**Fw: Ft Gillem Summary of Site Conditions**

Subject: TSS Recommendations for Investigation

Fort Gillem, Forest Park, Georgia

## SUMMARY OF SITE CONDITIONS

## FTG-09 SOIL GAS STUDY

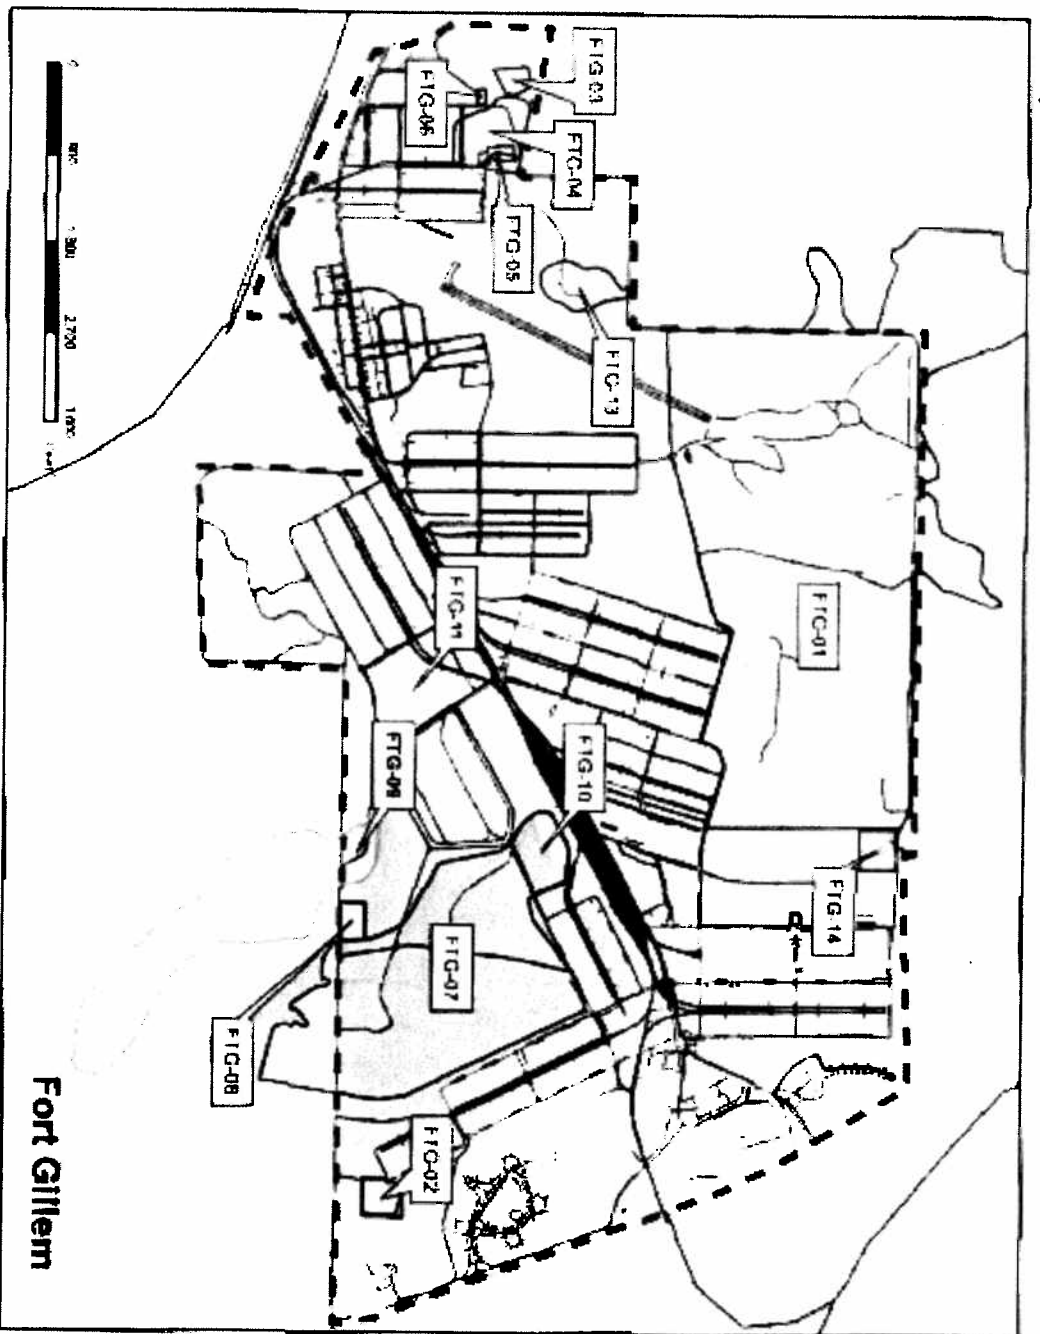
In the fall of 2004, 86 soil gas samples were collected from the residential area south of the post in the FTG-09 area. Using the maximum analytical data points for the VOCs detected, the Vapor Intrusion Screening Calculator Excel sheet was used to estimate the risk. Three compounds have notable risk. TCE with risk at  $8.3\text{e-}5/\text{HQ}=17$ , which is in excess of the benchmark of  $\text{HQ}=1$ , chloroform with risk at  $2.0\text{e-}5/\text{HQ}=0.02$  and PCE with risk at  $1.4\text{e-}6/\text{HQ}=0.31$ . This 2004 report worked through the screening tables included in the 2002 VI Guidance. These recent calculations were made with the 2012 screening calculator which has updated toxicity values for compounds. It is notable that while the total risk for this study is less than  $1\text{e-}4$  because none of the maximums were co-located, the risks were generally less than the corresponding risks derived from the 2012 groundwater data. Additionally, this study did not include analytical results for 1,1,2,2-TeCA which exhibited risk in other studies both groundwater and soil gas.
